NTD-NRC-94-4110  
DCP/NRC0044  
Docket No.: STN-52-003

SUBJECT: WESTINGHOUSE RESPONSES TO NRC REQUESTS FOR ADDITIONAL  
INFORMATION ON THE AP600

NTD-NRC-94-4110  
ATTACHMENT A  
AP600 RAI RESPONSES  
SUBMITTED APRIL 28, 1994

Figure 230.47-1 Factor of Safety To Resist Overturning

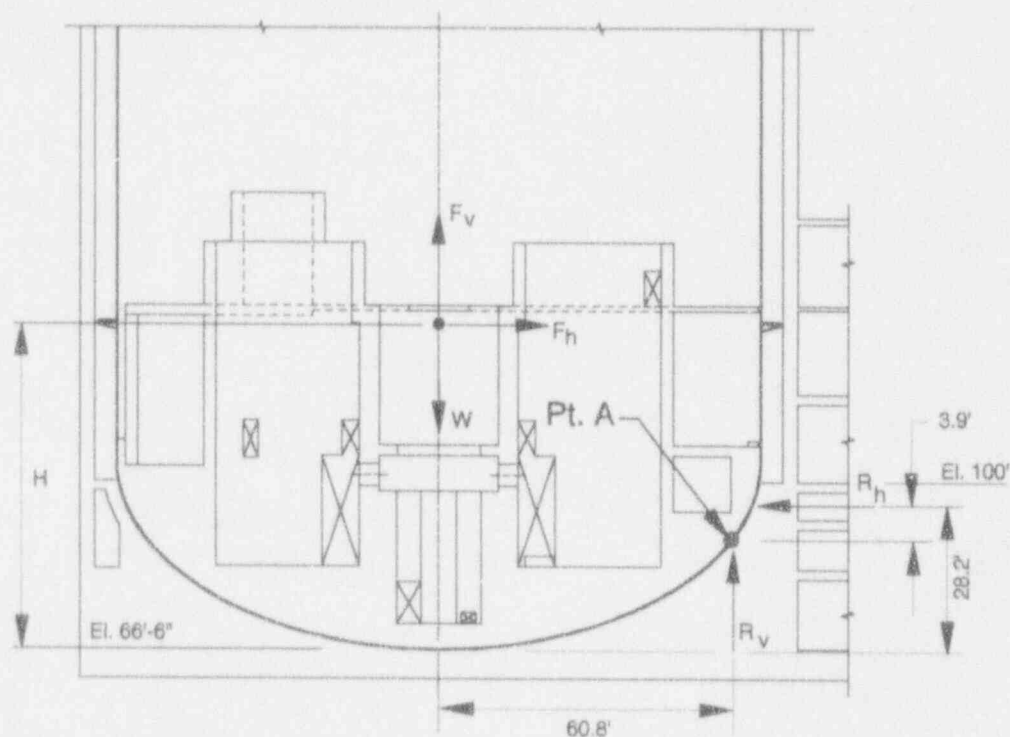
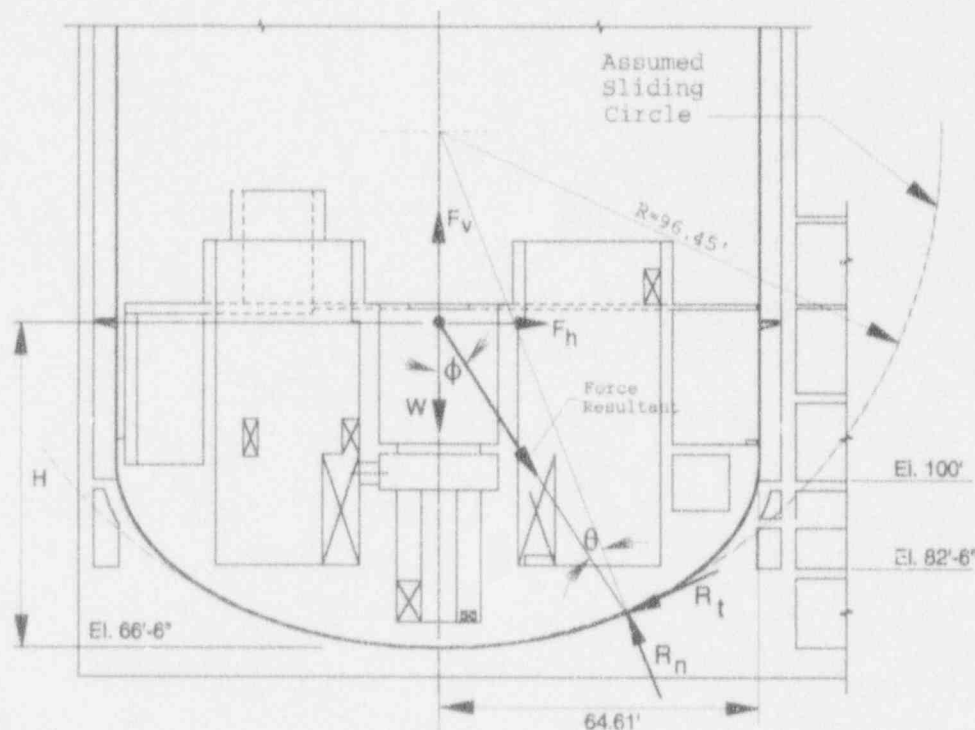
Section 3.8.2.1.2 of the SSAR states that the vertical and lateral loads on the containment vessel and internal structures are transferred to the basemat below the vessel by friction and bearing. This statement implies that there are no shear studs or anchors between the internal structures, steel containment vessel and reinforced concrete basemat. Provide an analysis to demonstrate the dynamic stability of the containment vessel during an SSE event or a seismic margins earthquake.

There are no shear studs or anchors between the internal structures, steel containment vessel and reinforced concrete basemat. The dynamic stability of the containment vessel was evaluated for a SSE event using a conservative friction coefficient of 0.4 at the concrete/steel interface. The factors of safety computed are equal to 2.5 and 3.0 against overturning and sliding, respectively.

The evaluation is graphically presented in Figures 230.47-1 and 230.47-2 using the following input data:

The dynamic stability analysis for the safe shutdown earthquake shows a large safety factor of 2.5 against overturning. Based on an analysis similar to that shown in Figure 230.47-1, incipient overturning would be predicted at a ground input level of 0.79g for an earthquake having a similar response spectrum shape as the safe shutdown earthquake. This would not represent failure since small lift-off would not prevent safe shutdown. Dynamic stability is therefore assured for the seismic margins review level earthquake.

$$\text{Overturning Moment} = F_h * 41.1 + F_v * 60.8 = 1,498,606 \text{ K-ft}$$

$$\text{Resisting Moment} = W * 60.8 + R_h * 3.9 = 3,812,417 \text{ K-ft}$$

$$\text{Factor of Safety} = \frac{\text{Resisting Moment}}{\text{Overturning Moment}} = 2.5 \geq 1.1$$
